Memorandum

CS Memorandum No. 1301

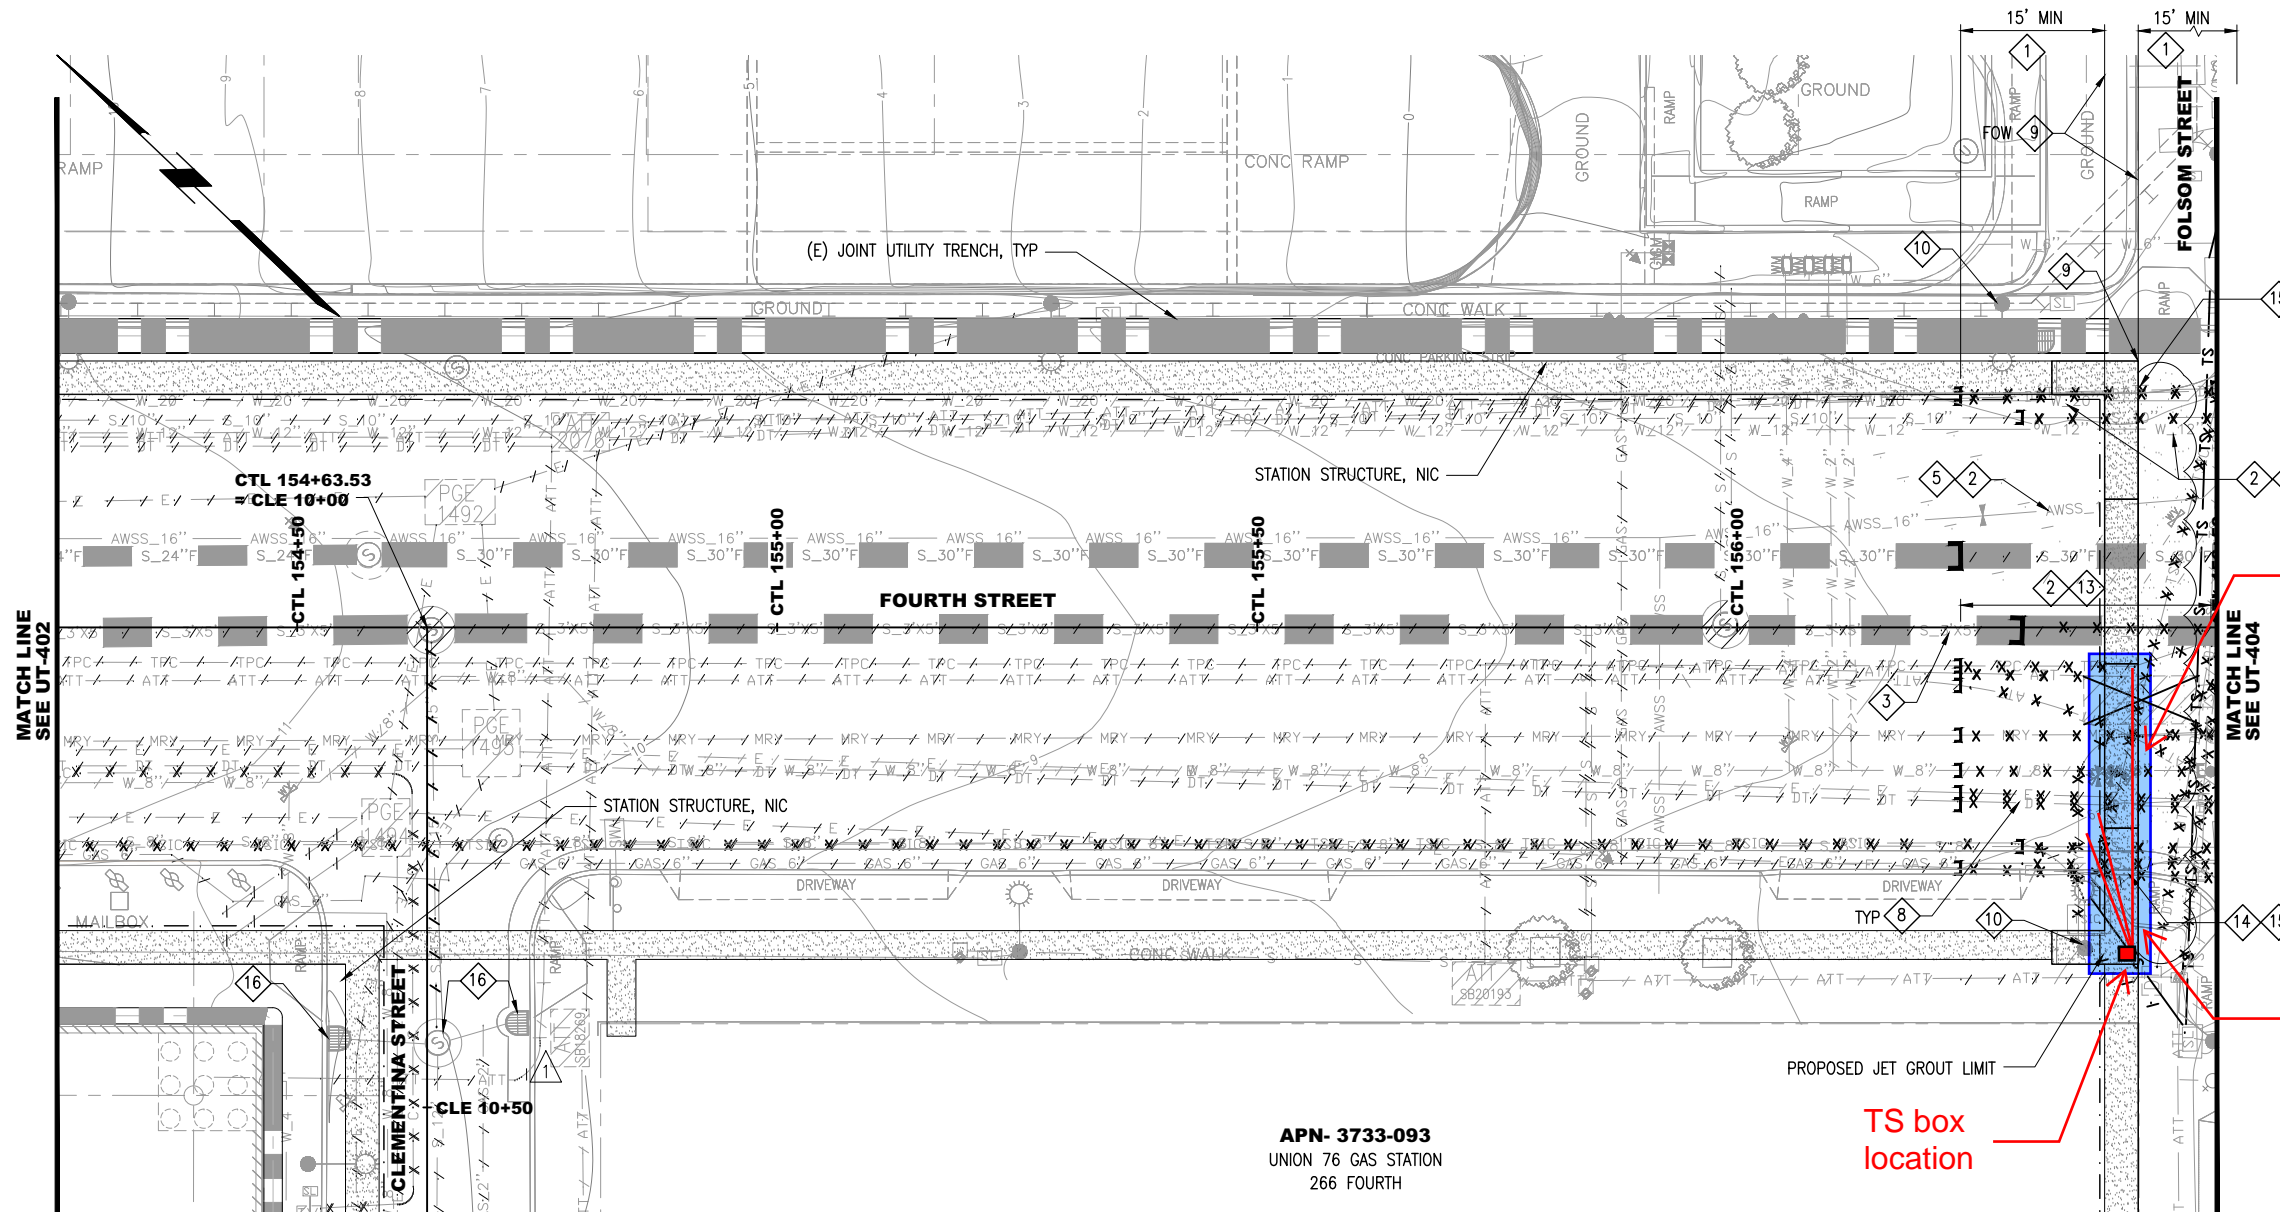
- 06/18/12 - BIH/SPM submitted RFI 103 to address the existence of a SFDT utility box located against the southwest corner of the south MOS headwall.
